FIELD INSPECTION

Project Name:	Mountain Valley Pipeline	Inspector:	Marshall Willis
Inspection Date:	Tuesday, February 19, 2019	Project Contact:	Brian Clauto
Spread I: Franklin County	STA 14062+17 – 14042+83 STA 14272+24 – 14274+00 STA 14129+00 – 14171+75	Weather (Wet/Dry/Rain):	Dry

FIELD INSPECTION PHOTO LOG

Fig. 2: STA 14272+24 – Stabilization needed.

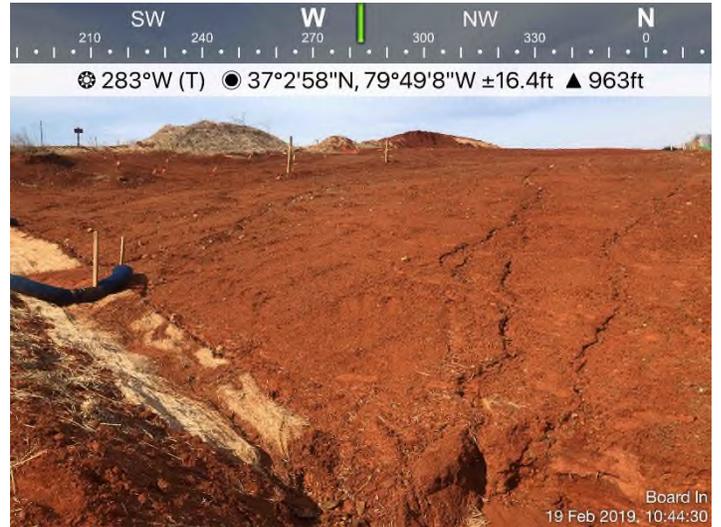
- Streams / wetlands inspected included: S-YZ4, S-YZ5, S-C8 and S-KL51.
- Waterbar does not have positive drainage at STA 14049+30.
- Further stabilization needed at STA 14272+24. Rill erosion evident.
- P1 and CFS need maintenance at STA 14273+25.
- SSF needs repair in ATWS 1478.
- Sump full at GAS S-C8.
- CFS needs maintenance at STA 14148+57.
- Stabilization needed adjacent to S-KL51.

Recommended Corrective Action: Maintain and install all controls per the approved plan and specs.
